APPLICATION NO.	FILING DATE	FIRST NAMED INVENTOR	ATTORNEY DOCKET NO.	CONFIRMATION NO.
10/695,958	10/30/2003	Timothy Bernard Allmandinger	8200.623	6266
7590	09/06/2005			
Liniak, Berenato, Longacre & White Ste. 240 6550 Rock Spring Drive Bethesda, MD 20817			EXAMINER	HO, HA DINH
			ART UNIT	PAPER NUMBER
			3681

Office Action Summary	Application No.	Applicant(s)	
	10/695,958	ALLMANDINGER ET AL.

DETAILED ACTION

FIG. 14

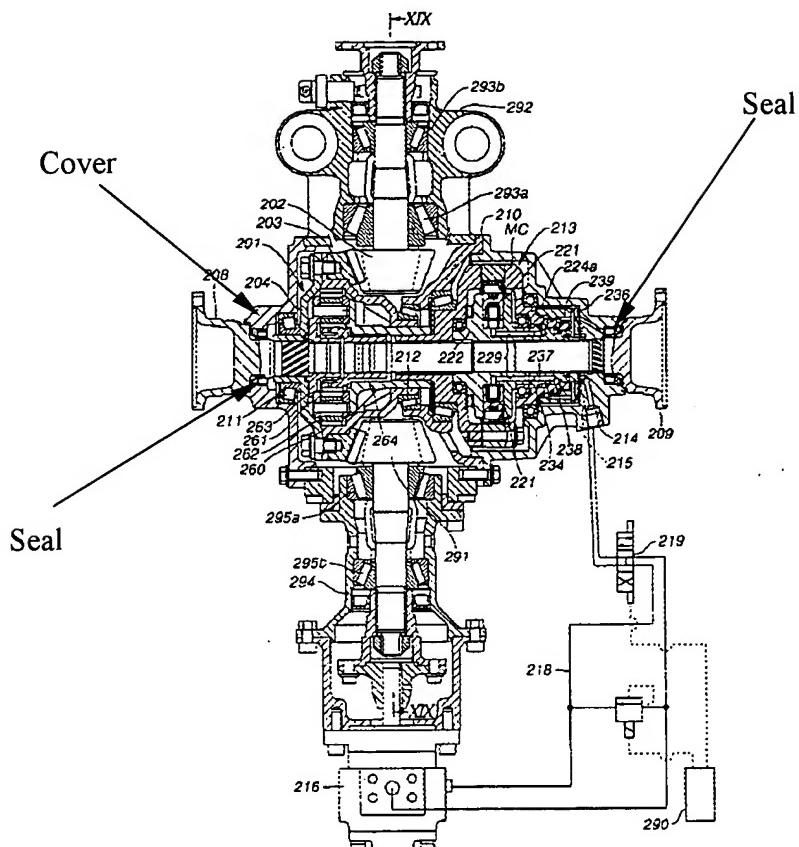
Otaki et al disclose a dive axle assembly for a motor vehicle (see Fig. 14) comprising a support beam member (292), a differential assembly module (201) secured to the support beam member, a pair of axle shaft members (208, 209), and a cover member (see inserted Fig. 14 on next page) fastened to the support beam and having two coaxially spaced access openings therein

for receiving the axle shaft members (208, 209) therethrough, each of the access opening provided with a sealing device (see the inserted Fig. 14).

Otaki et al do not show the sealing devices being adjustable relative to the cover member. Lansdale discloses an adjustable sealing flange device (54, 56) (see Fig. 3) provided on the cover member (52) to seal an interior cavity within the cover member between the access opening and the rotating shaft (50), wherein the adjustable sealing flange device (54, 56) is adjustable relative to the cover member.

It would have been obvious to one of ordinary skill in the art at the time the invention was made to replace the sealing device of Otaki et al by the adjustable sealing flange device of Lansdale so that the seal can be properly centered relative to the shaft center because the function of the seal will be adversely affected if the gap to be sealed is wider on one side than the other (col. 1, lines 22-27).

Note that the modified drive axle assembly would have all the features recited in claims 21-25. Further, the cover member would be provided with a plurality of holes for fastening the sealing flange device to the cover as taught by Lansdale.
